To : Parts Warehouse Department
From : Quality Control Department
Re : Product Parts Change
Date : November 28, 2025
Reference no.: QCD-000-25-A-103
Cc. : PROD'N / SERVICE / PCO / SALES / ENG. / DCO

We would like to inform your good office that, based on the results of our IQC inspection, we have identified changes in certain parts of the product listed below.

P/O. Number	Model	Quantity	Serial Number Range
KT-2509FM-01	KAC-36TCRM	808 units	14032509-12367 to 13174
	KAC-48TCRM	585 units	14042509-11801 to 12385

1. EXTERNAL PARTS:

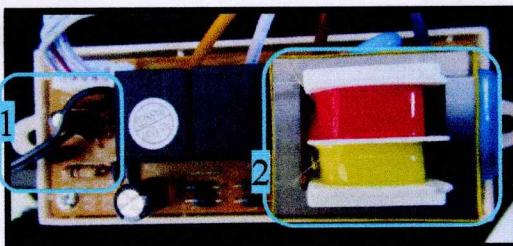
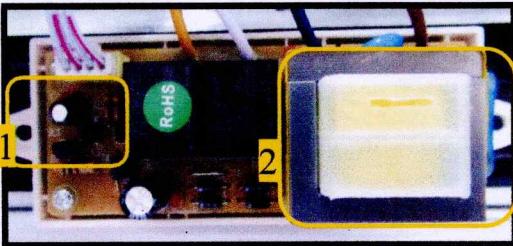
With AIR CURTAIN printed and with POP sticker on front panel

2. INTERNAL PARTS:

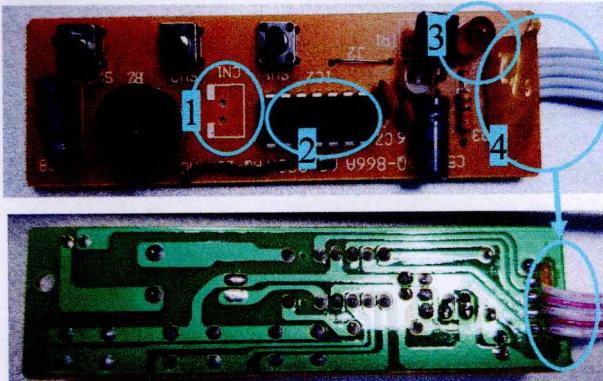
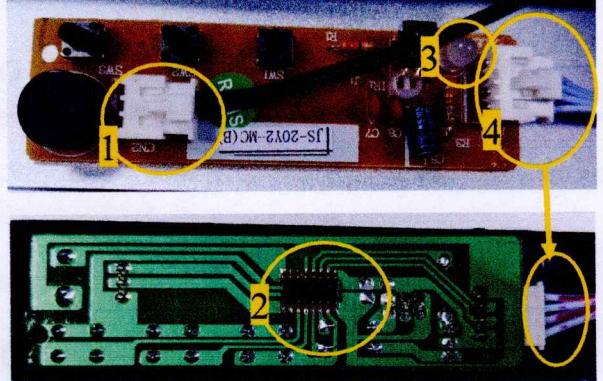
PREVIOUS MAIN PCB/ POWER SUPPLY	NEW MAIN PCB/ POWER SUPPLY
 <p> NY-866-FRZ 220V / 6.3A </p> <p> 1. The DOOR sensor was connected 2. The transformer has no cover </p>	 <p> DY-2J (10) B220-W0(Y) B3 220-240V / 10A </p> <p> 1. Removed the DOOR sensor and transfer to display board 2. The transformer has cover </p>

PREVIOUS DISPLAY / CONTROL BOARD	NEW DISPLAY / CONTROL BOARD
 <p>AQ-866A / AQ-833A / AQ-20M-MC</p> <ol style="list-style-type: none"> 1. No DOOR sensor connector 2. The IC was located on front 3. RED LED indicator 4. 5 wires connector terminals (silicon) 	 <p>JS-20Y2-MC (B)</p> <ol style="list-style-type: none"> 1. With DOOR sensor connector 2. The smaller IC located at the back 3. RED and GREEN LED indicator 4. 4 wires connector terminals (clip type)

Remarks: The new parts can also be used in previous units because they have the same dimensions.
